HISTORIC AND DESIGN REVIEW COMMISSION

HDRC CASE NO: 2020-096
ADDRESS: 632 LEIGH ST
LEGAL DESCRIPTION: NCB 2739 BLK LOT W 41.6 FT OF A19
ZONING: R-5, H
CITY COUNCIL DIST.: 1
DISTRICT: Lavaca Historic District
APPLICANT: Brian Voges/Voges Design
OWNER: MONTEMAYOR VERONICA
TYPE OF WORK: New construction of 2-story residential structure
APPLICATION RECEIVED: February 28, 2020
60-DAY REVIEW: April 28, 2020
CASE MANAGER: Rachel Rettaliata

The applicant is requesting conceptual approval to construct a new 2-story, single-family residence at 632 Leigh.

1 PRELIM ELEVATION STUDY

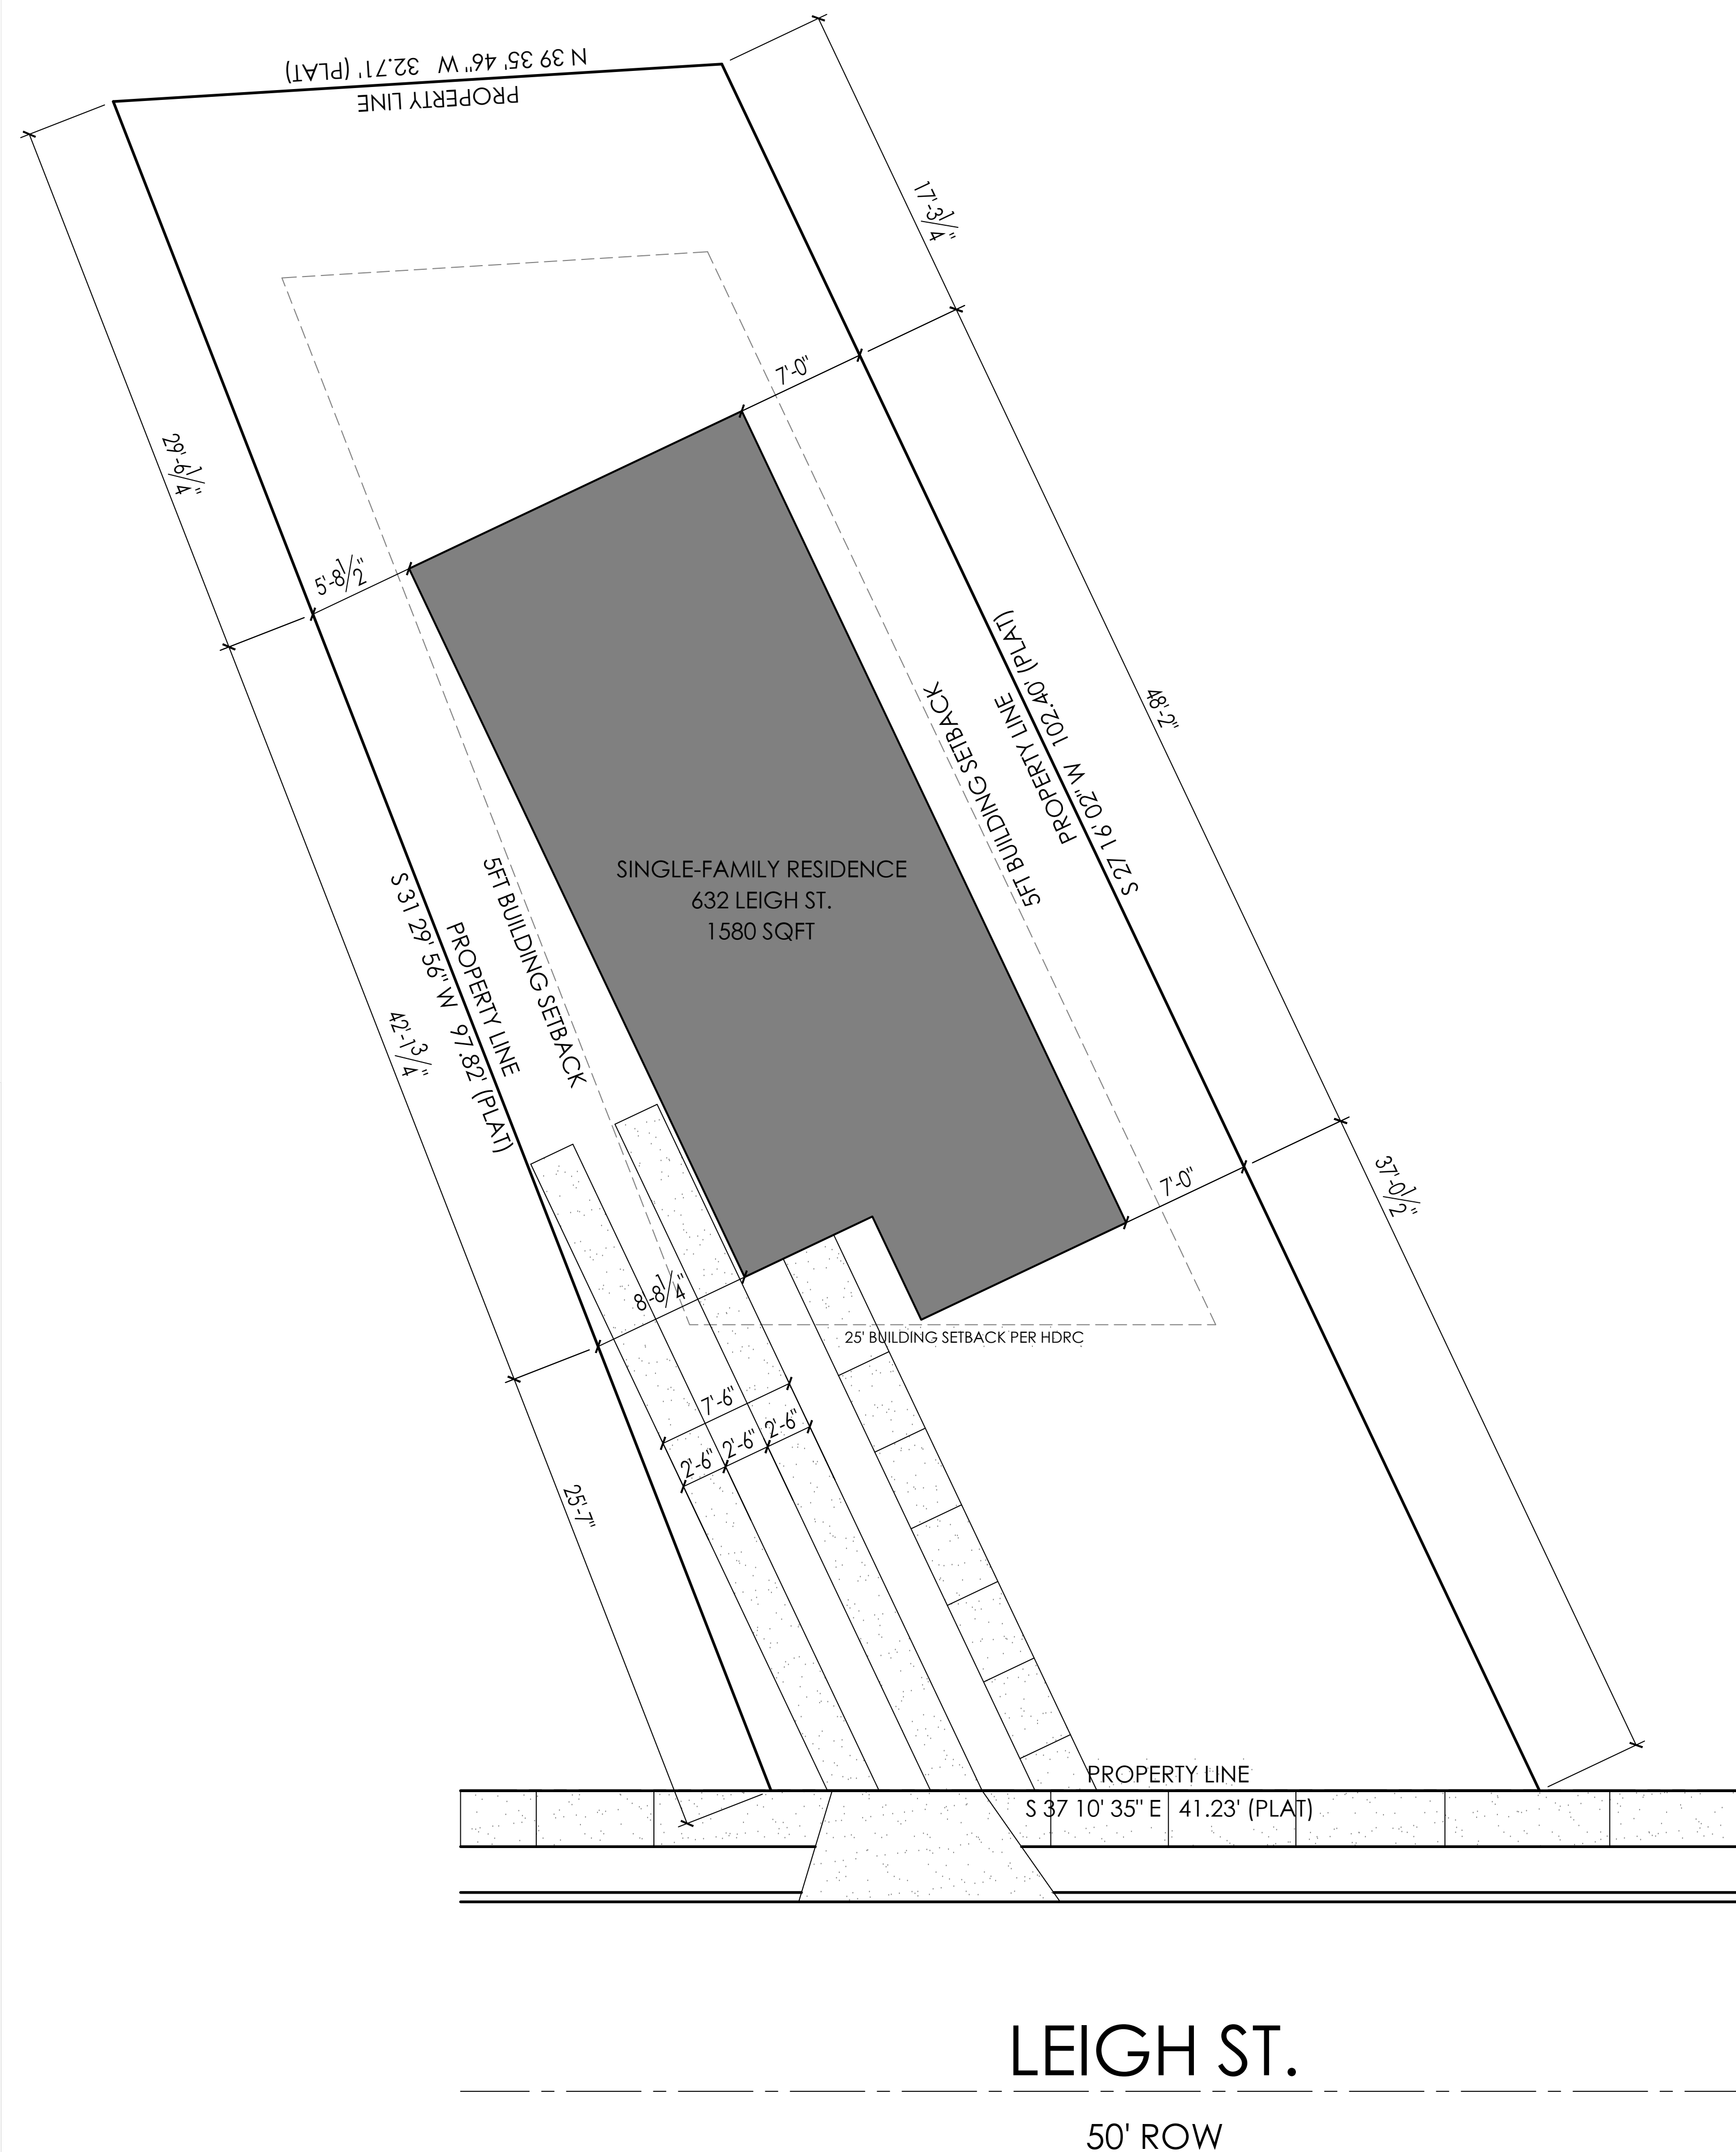
- e. SCALE AND MASSING – According to Guideline 2.A.i for New Construction, new structures should feature a height and massing that is similar to historic structures in the vicinity. In residential districts, the height and scale of new construction should not exceed that of the majority of historic buildings by more than one story. The block within the Lavaca Historic District features 1-story historic structures and 2-story units of new construction. The opposite side of Leigh that is outside of the Lavaca Historic District features 2-story and 3-story infill. Staff finds that the proposed scale and massing of the structure appears generally appropriate.

- f. ROOF FORM – The applicant has proposed a pyramidal roof with a projecting front gable. According to Guideline 2.B.i for New Construction, new construction should feature roof forms that are consistent with those predominantly found on the block. The adjacent structures on Leigh feature front gable, cross gable, flat, shed, and pyramidal roof forms. Staff finds the proposal consistent with the Guidelines.

- j. **RELATIONSHIP OF SOLIDS TO VOIDS** – Guideline 2.C.i for New Construction stipulates that new construction should incorporate window and door openings with a similar proportion of wall to window space as typical with nearby historic facades. Windows, doors, porches, entryways, dormers, bays, and pediments shall be considered similar if they are no larger than 25% in size and vary no more than 10% in height to width ratio from adjacent historic facades. The applicant has only submitted the front elevation for review. The applicant should submit all elevations to staff for approval.

- vi. That the applicant submit elevation drawings for each elevation to staff for review and approval.
- vii. That the applicant submit a landscaping plan to staff for review and approval.

2 SITE PLAN

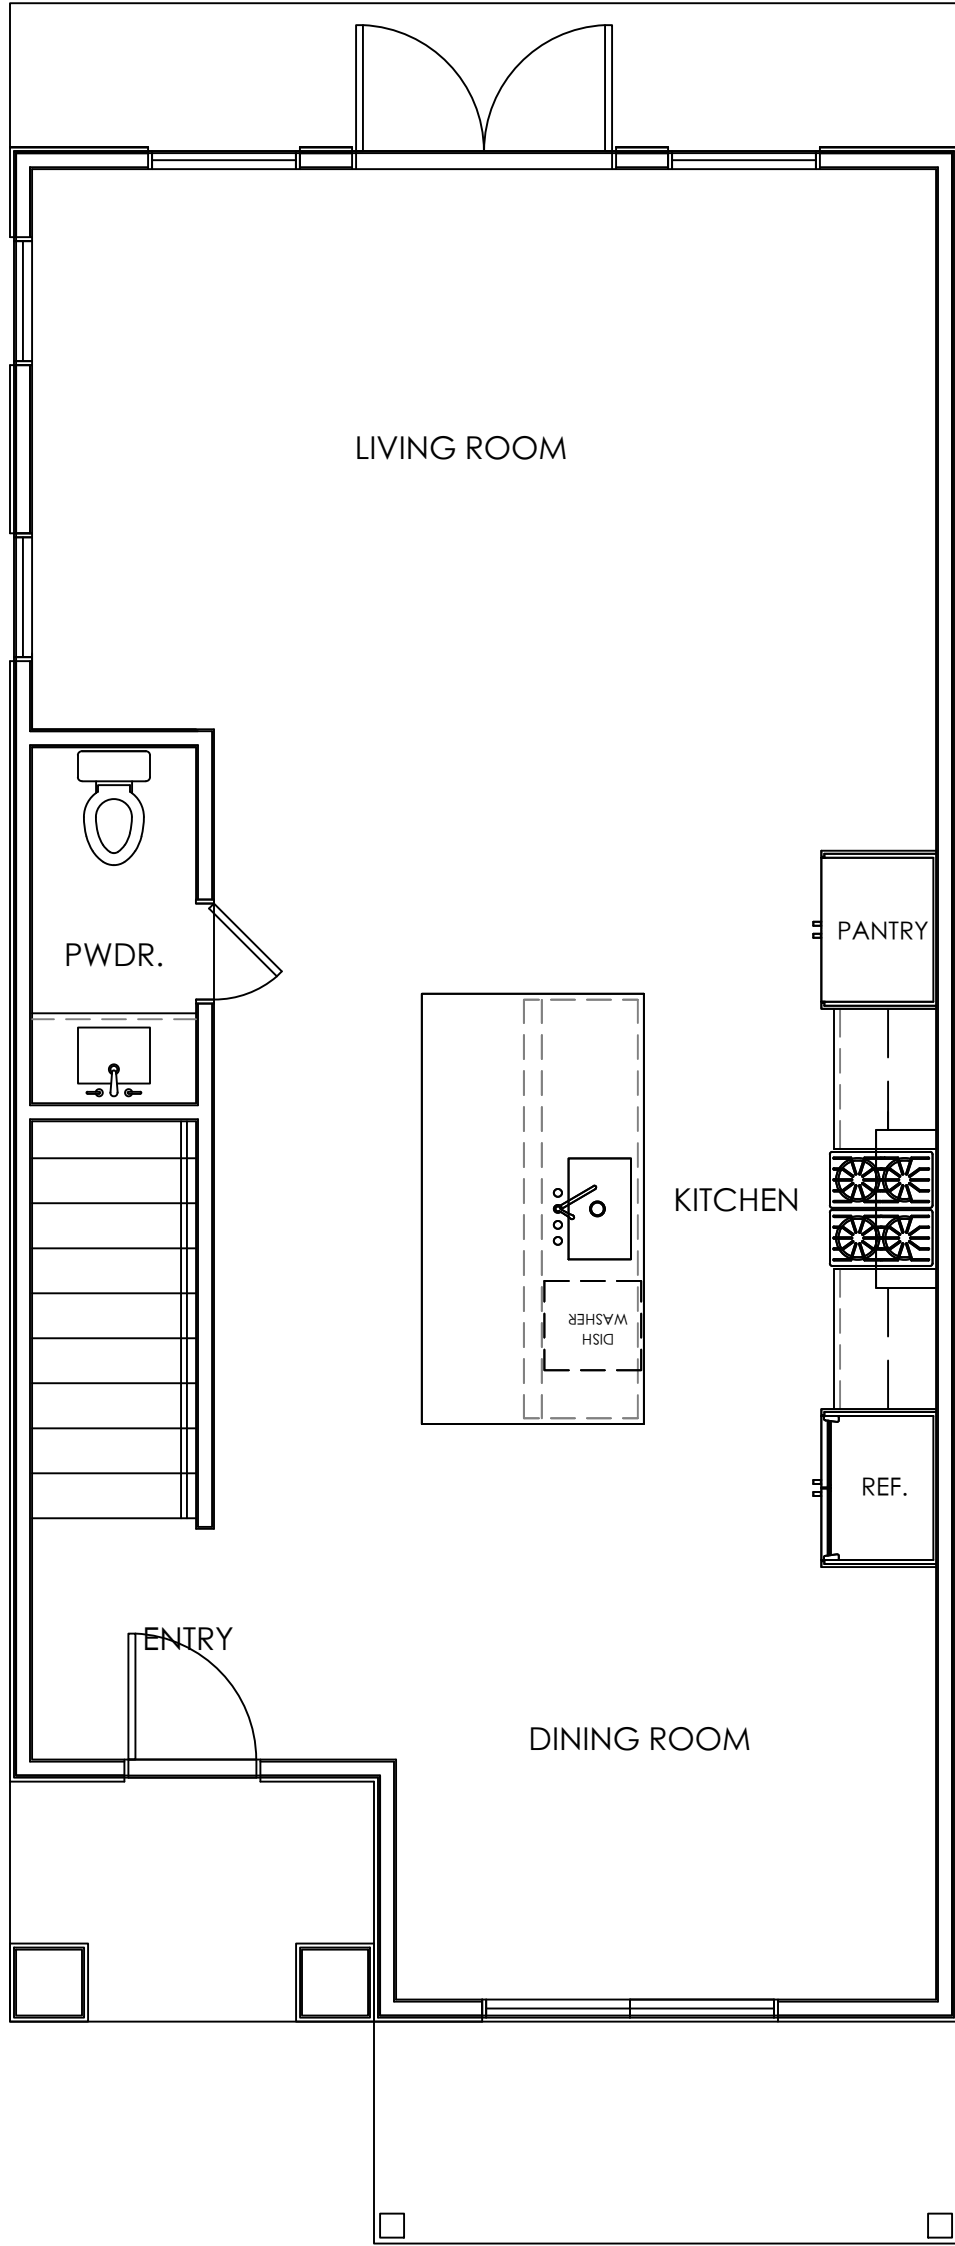
- c. DESIGN REVIEW COMMITTEE – The applicant presented the application materials at the Design Review Committee on March 10, 2020. The commissioners present were generally receptive to the proposal and suggested that due to the irregular lot, the applicant should submit a site plan showing the footprint of the adjacent structures. Additionally, the commissioners recommended that the applicant provide an elevation showing the heights of adjacent properties.

- d. SETBACK & ORIENTATION – According to the Guidelines for New Construction, the front facades of new buildings should align with the front facades of adjacent buildings where a consistent setback has been established along the street frontage. Additionally, the orientation of new construction should be consistent with the historic examples found on the block. The applicant has proposed to construct a 2-story, single family residence at 632 Leigh. The frontage of the residence will be oriented toward Leigh. Staff finds the proposal consistent with the Guidelines.

construction to no more than 50 percent of the total lot area, unless adjacent historic buildings establish a precedent with a greater building to lot ratio. The applicant has proposed to construct a 1,580-square-foot residence. The proposed new construction will cover less than 50 percent of the total lot area. Staff finds the proposal consistent with the Guidelines.

- l. **DRIVEWAYS** – Guideline 5.B.i for Site Elements notes that new driveways should be similar to those found historically within the district in regard to their materials, width, and design. Additionally, the Guidelines note that driveways should not exceed ten (10) feet in width. The applicant has proposed to install a two-ribbon driveway with ribbon widths of 2’-6” and a total width of 7’-6”. Staff finds the proposal consistent with the Guidelines.

- m. **FRONT WALKWAYS** – The Guidelines for Site Elements note that front yard sidewalk should appear similar to those found historically within the district in regard to their materials, width, alignment and configuration. The applicant has proposed to install a front-yard walkway to the entry door. The applicant should submit specifications for the width of the walkway and the proposed material to staff for review and approval.

SC: BC THE LOT IS IRREGULAR, SHOW THE FOOTPRINT OF THE
ADJACENT STRUCTURES.
